HISTORIC PRESERVATION BOARD

PUBLIC HEARING
30-32 ATLANTIC STREET

TO: Chair Pollard and Members of the Historic Preservation Board
FROM: Rob Wiener, Historic Preservation Compliance Coordinator
DATE: November 12, 2021
RE: November 17, 2021 **PUBLIC HEARING – Final Review of Proposed
Multifamily Residential Infill Construction
HPBR-001790-2021**

Re: 30-32 Atlantic Street, design changes since 10/06/21 HP workshop

④ Section thru Cornice @ Main Roof
1" = 1'-0"

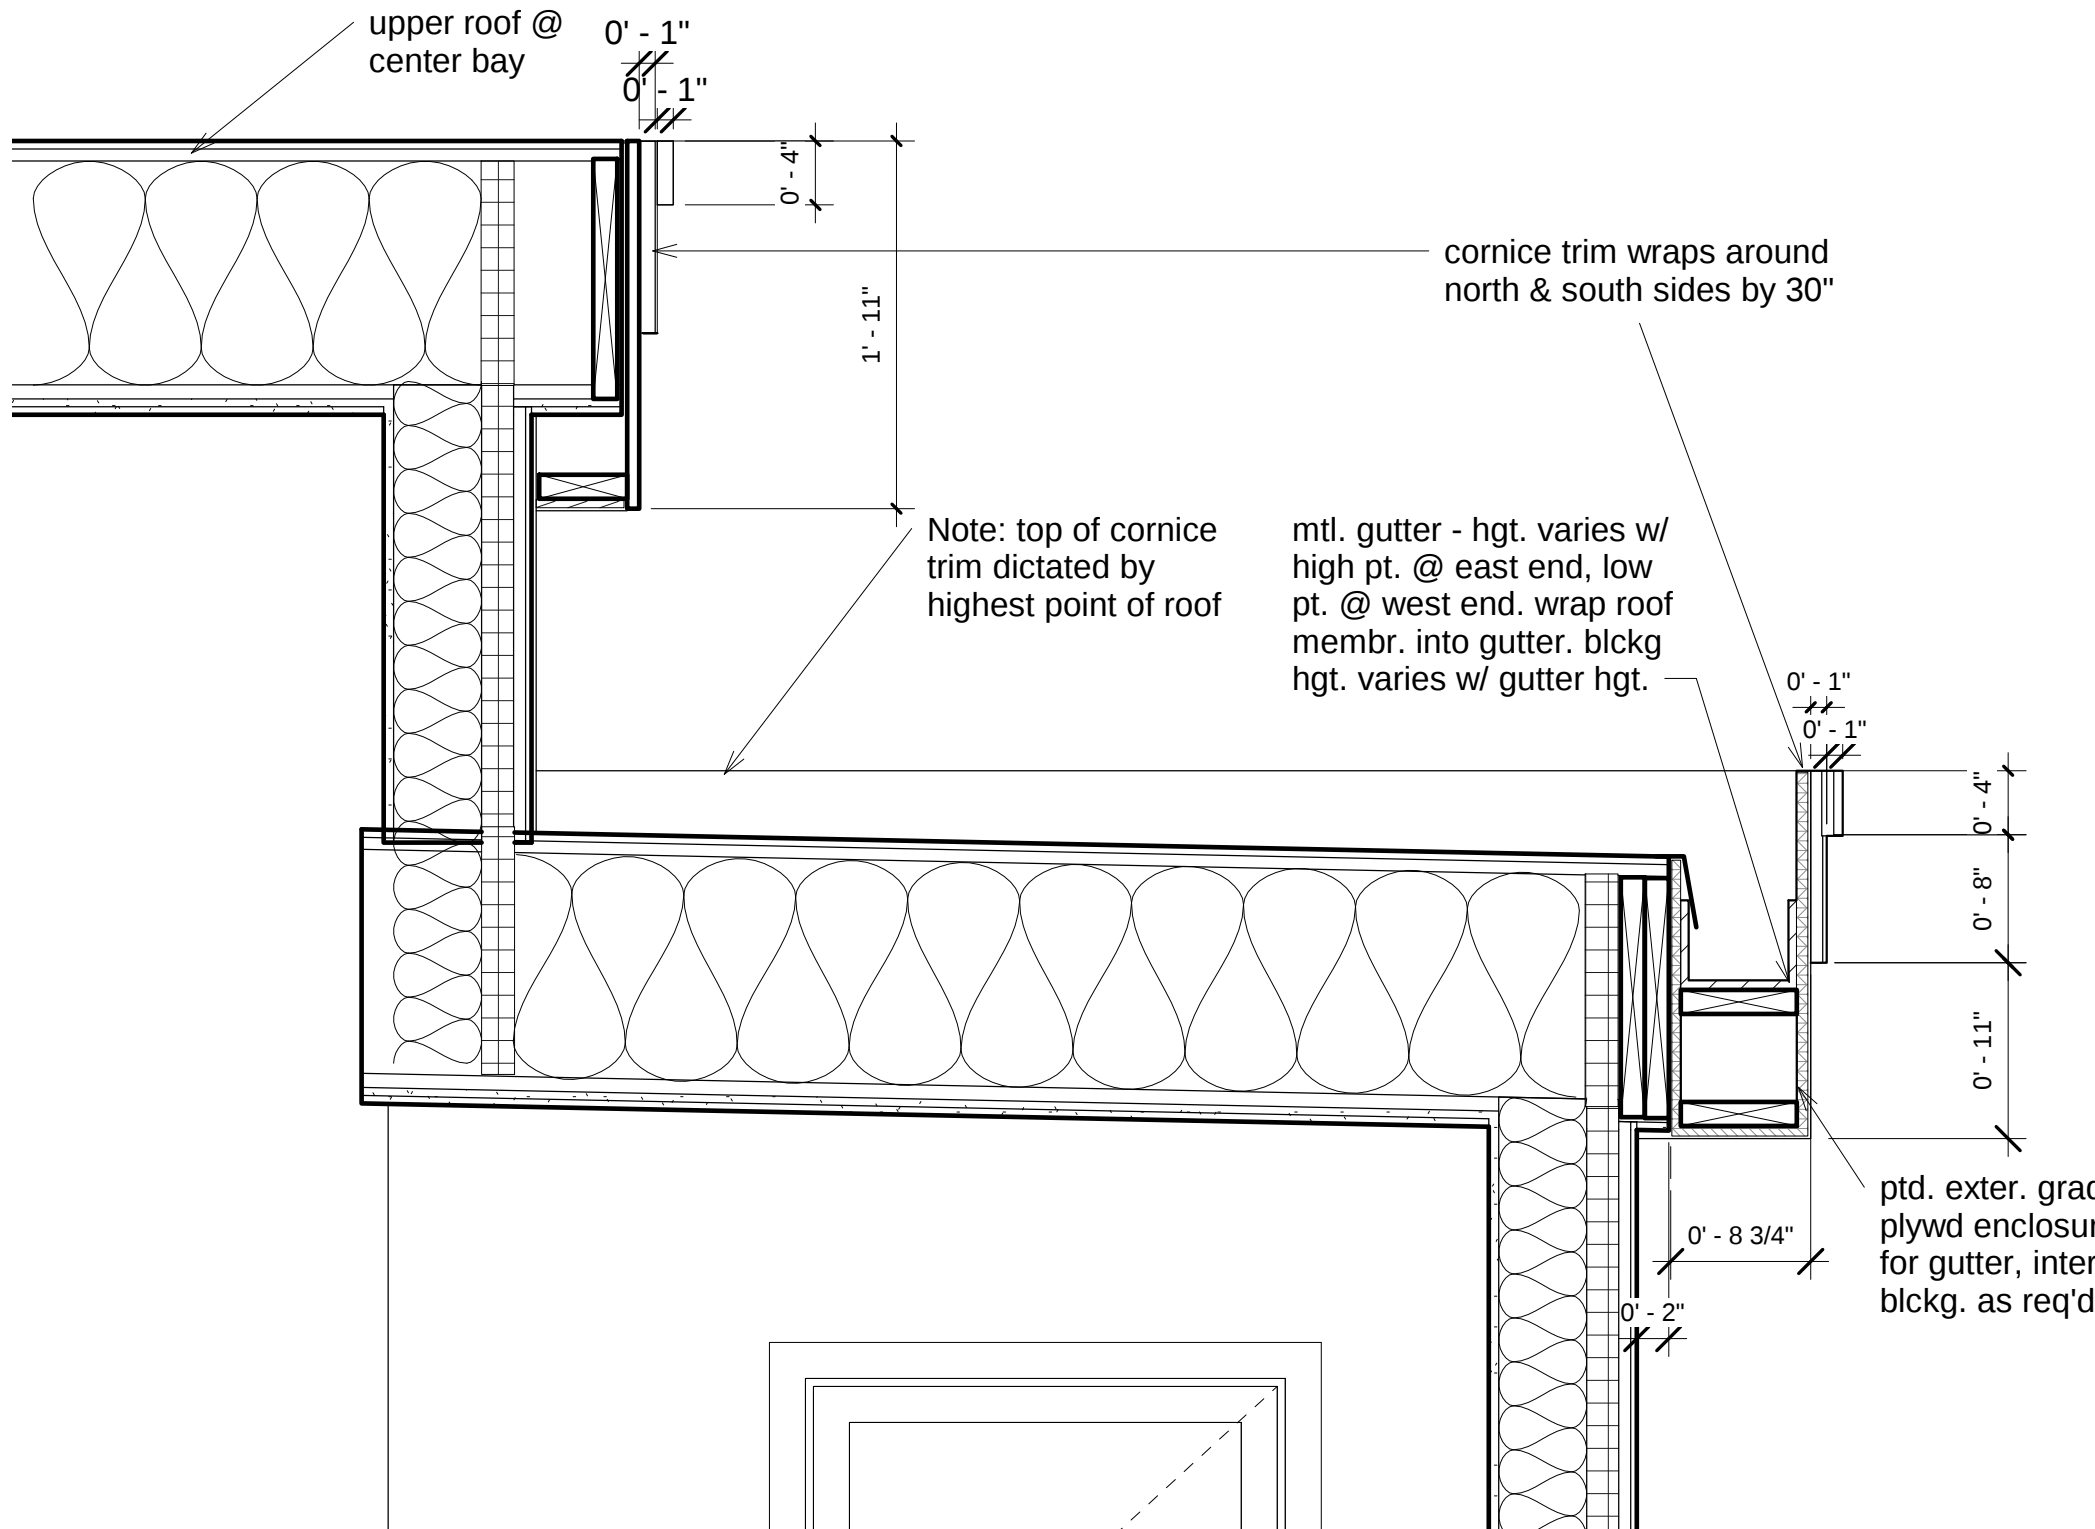
- Staff appreciates that the architect has clarified the cornice details. It is quite a wide cornice (1'-11") but is only articulated on the front face, with short "returns" and the north and south front corners. On the other three sides of the building, there is a wide, flat fascia (also 1'-11") that hides the minimal roof slope and the gutter that slopes toward the rear. Do Board members think the weight, width, and level of articulation of the cornice and fascia are compatible with the rest of the building?

4. *Mechanical Units* on the roof are now screened with a simple lattice wall that will be similar to the vertical siding.
5. A *Cornice* detail has been added to clarify the dimensions of the cornice. Please note that the overall height of the cornice is required to conceal the slope of the roof from its high point at the center to its low points along the north and south walls; while technically a flat roof, it is slightly pitched to north and south sides for run-off. See detail 4/A403.

6. The *Fascias* along the north and south elevations have been simplified and clarified; the fascias conceal sloped gutters within, to pick up all of the roof run-off and direct the water to leaders at the west end of the building that are then connected to the rain garden in the west/rear yard. See detail 5/A403.
